| Project | IEEE 802.16 Broadband Wireless Access Working Group < http://ieee802.org/16 > |
| Title | Ranging Improvement for 802.16e OFDMA PHY |
| Re: | IEEE P802.16-REVe/D3-2004 Ballot #14b |

Figure XXXa. Dedicated ranging interval

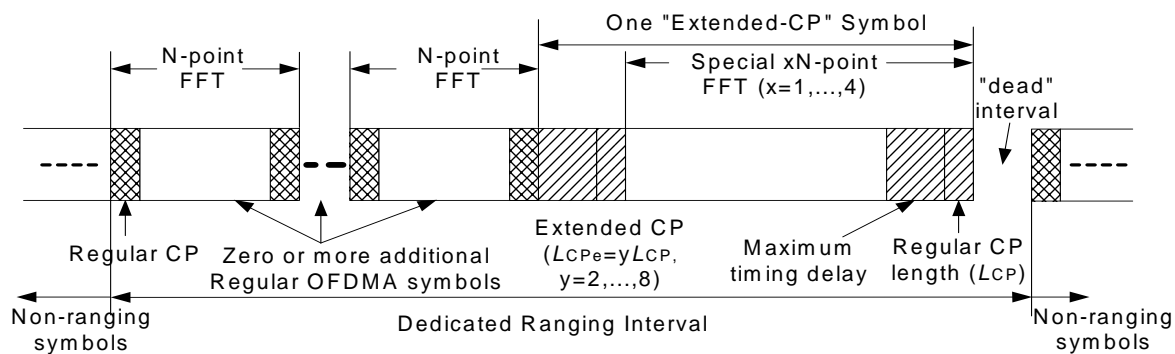
8.4.7 OFDMA Ranging

When used with the WirelessMAN-OFDMA PHY, the MAC layer shall define a dedicated ranging interval. This ranging interval is composed of one special OFDMA symbol with an extended cyclic prefix (CP) that may be preceded by up to four regular OFDMA symbols with a regular CP for providing more ranging opportunities if needed. The duration of the extended CP, which shall equal to the summation of the regular CP length and the largest timing difference to be accommodated, is signaled by the base in the UL-MAP message as an integer multiple of the regular CP. Similarly, the FFT size of the extended-CP symbol, which shall also be an integer multiple of the regular FFT size, is signaled in the UL-MAP message as well. Immediately after the special OFDMA symbol, there is a “dead” interval that equals the largest timing difference. But it may be omitted to trade performance degradation for overhead reduction. The UL-MAP message shall signal whether the dead interval is included. The dedicated ranging interval is shown in Figure XXXa.

Figure XXXb. Ranging Opportunities in Frequency, Code, and Time

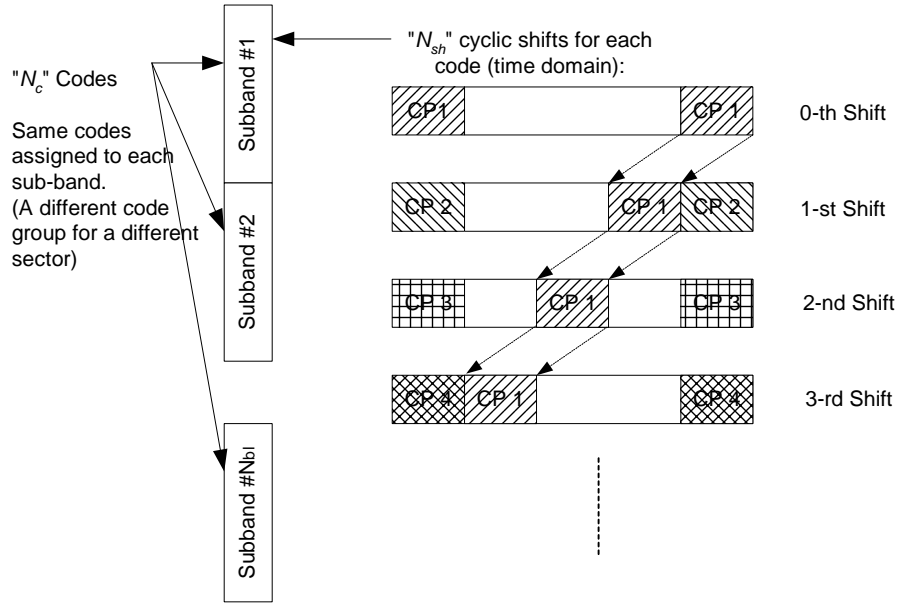
Lastly, before the CP is inserted, the ranging signal shall be cyclically (circularly) shifted in time domain, where the shift is chosen randomly among N_{sh} allowed values that are known to the BS and SS. Mathematically, the frequency domain sequence, after the j^{th} shift is

where $s(k)$ is the original (or 0th shift) sequence, L is the CP length and N_{FFT} is the FFT size. The suggested parameters for N_{sh} , N_c , and N_{bl} is given in 8.4.7.4 for the different FFT sizes and bandwidths. The division of ranging opportunities in frequency, time, and code is shown in Figure XXXb.
